UNITED STATES PATENT AND TRADEMARK OFFICE

APPLICATION NO.	FILING DATE	FIRST NAMED INVENTOR	ATTORNEY DOCKET NO.	CONFIRMATION NO.
10/614,277	07/08/2003	Haruyoshi Ono	030824	7735

Office Action Summary

DETAILED ACTION

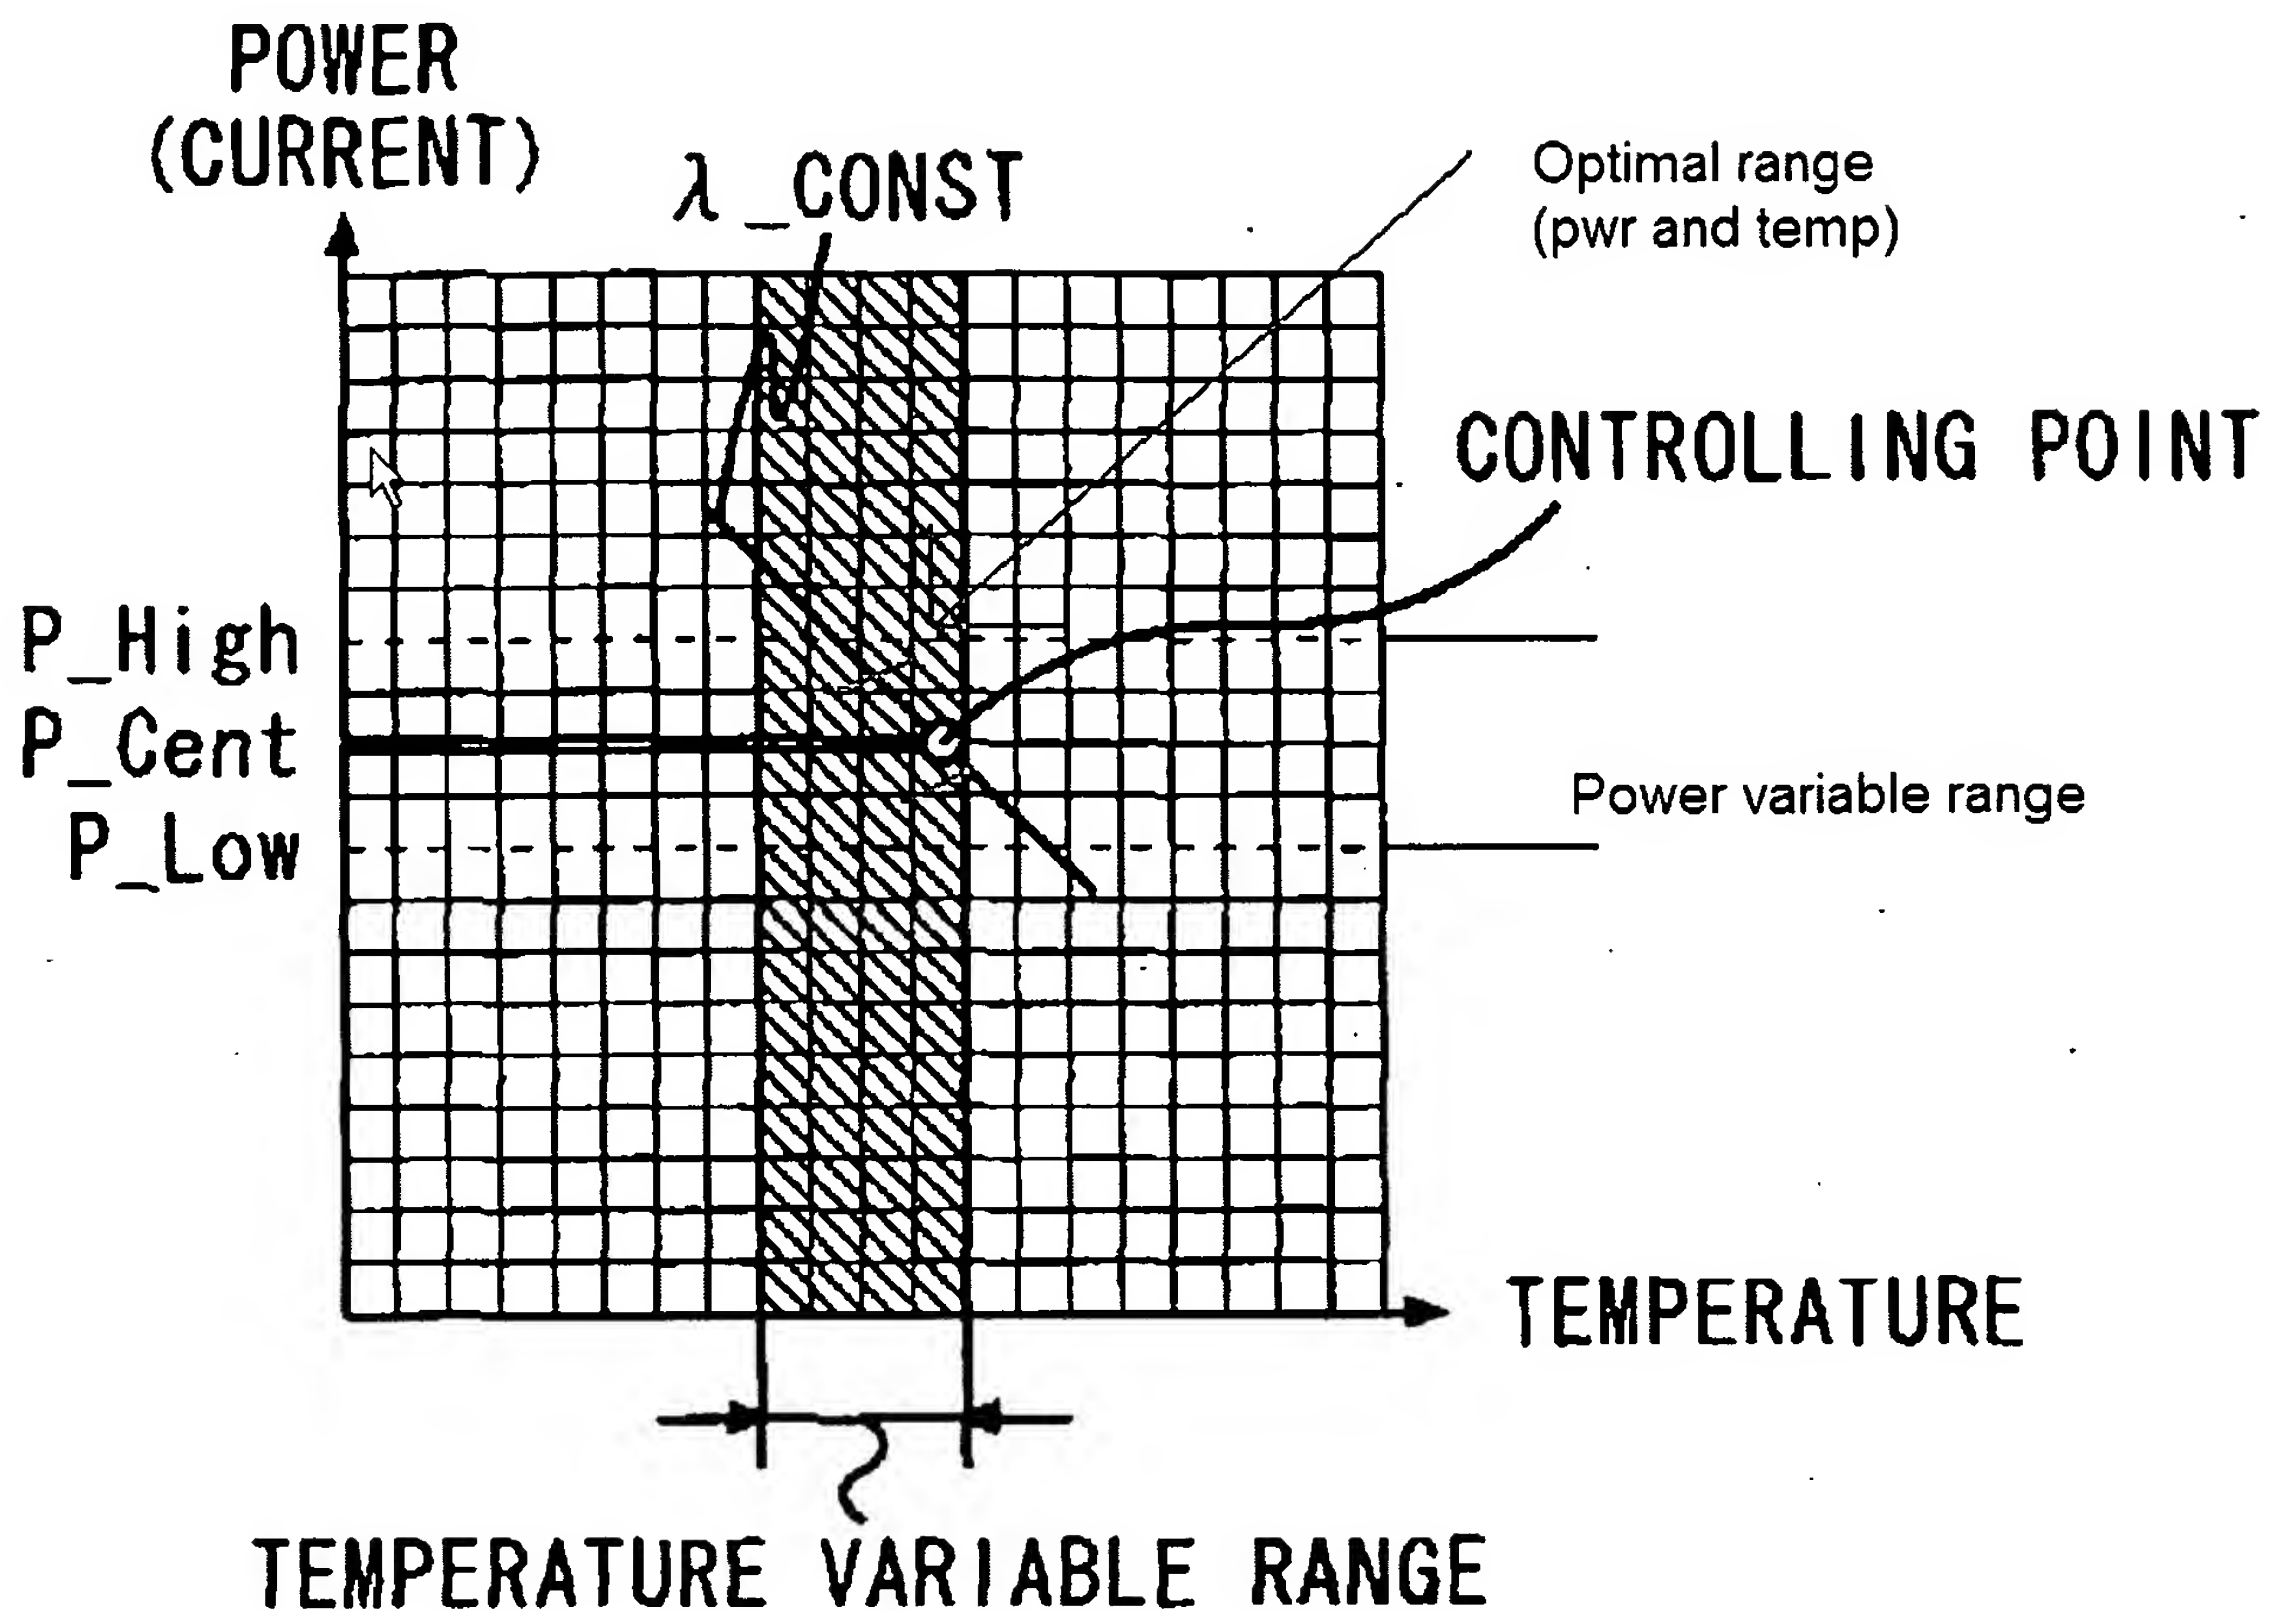
With respect to claims 9 and 19, the prior art discloses a setting value generating device that generates such a setting value that causes laser light emitted from a laser module to have a predetermined wavelength (λ target, spec. pg.4 line 17) and satisfies predetermined temperature conditions and predetermined power intensity conditions (fig.3a, defined temp / power ranges), the setting value generating device

comprising: an optimum power intensity calculating unit (fig.1 #120) that calculates an optimum power intensity setting range (fig.3a) that maintains the predetermined wavelength falls within a predetermined power intensity variable range (range can be considered equal to the intensity setting range, fig.3a) a predetermined power intensity variable range (maintained via APC feedback); an optimum temperature calculating unit (fig.1 #120) that calculates an optimum temperature setting range (fig.3a, pgs.4-5 lines 37-9) that maintains the predetermined wavelength and falls within a predetermined temperature variable range; and a setting value generating unit (fig.1 #120) that generates the setting value based on the optimum power intensity setting range (optimum is P_cent) calculated by the optimum power intensity calculating unit and the optimum temperature setting range calculated by the optimum temperature calculating unit (setting values generated based on temp/wavelength/power, pg.6 lines 17-21), wherein the laser module can be operated with the setting value that is located within the predetermined temperature setting range and the predetermined power intensity setting range even when the laser module cannot operate within the predetermined temperature variable range () at a center value of the predetermined power intensity variable range while the laser light is kept at the predetermined wavelength (As described at pg.2 lines 3-11 of the disclosure, the AAPA describes that the power value is controlled via an Automatic power control (APC), this control device is used to correct for minor deviations from a set value (P_cent), therefor, the module can have a value which is not the center value of the predetermined power intensity variable range, and the APC will adjust the driving current to return it to the P_cent value).

As the prior art shows (fig.3a), the laser module can be operated at a point which is not at P_{Cent} while maintaining the chosen constant wavelength. When this happens, the APC takes over to return the system to the optimal value. When the system is not at the optimal value (before APC adjustment) the output wavelength can be unchanged (along λ_{const} trend line) while inside both of the temperature and power predetermined variable ranges thereby reading on the claim limitations.
